SERVICE BULLETIN

B-066

2006-2007 ULYSSES XB12X BANK ANGLE SENSOR RECALL

Figure 1. Bank Angle Sensor (current location)

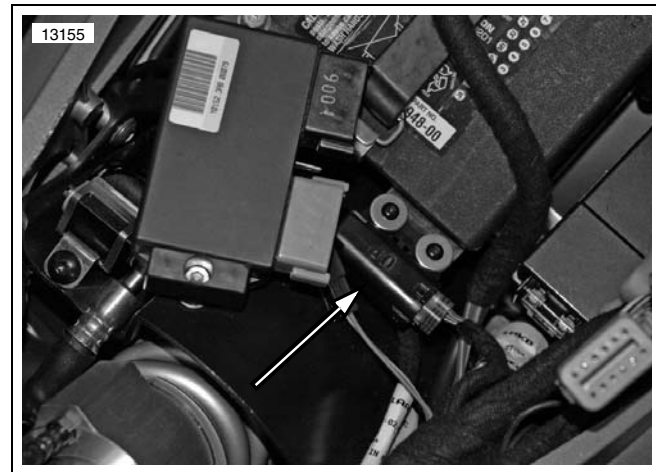
2. Disconnect negative battery cable.
3. See Figure 1. Remove screws and washers to detach BAS.
4. Unplug bank angle sensor connector and remove BAS.

Figure 2. Bank Angle Sensor Bracket (Mounting bracket turned upside down for clarity)

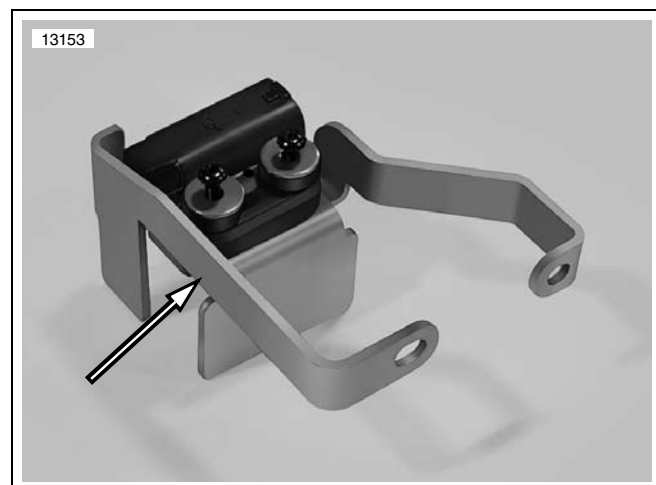
1. See Figure 2. Install bank angle sensor to the underside of the mounting bracket with original fasteners. Tighten fasteners to 12-36 **in-lbs** (1.4-4.1 Nm).
2. Connect harness extension cord to main harness connector [134].
3. See Figure 4. Route the harness extension cord under the ECM and along the right tail section to the tail loop.
4. Route the harness extension cord below the rear auxiliary power outlet and behind the seat latch bracket.
5. Connect harness extension cord to BAS.
6. See Figure 4. Install the BAS mounting bracket to seat latch bracket using the original seat latch fasteners. Tighten the fasteners to 60-96 in-lbs (6.7-11 Nm).
7. See Figure 3. Using the wire retaining clips with self adhesive backing, attach the harness extension cord to the right tail section.
8. Connect negative battery cable. Tighten fastener to 72-96 in-lbs (8-11 Nm).
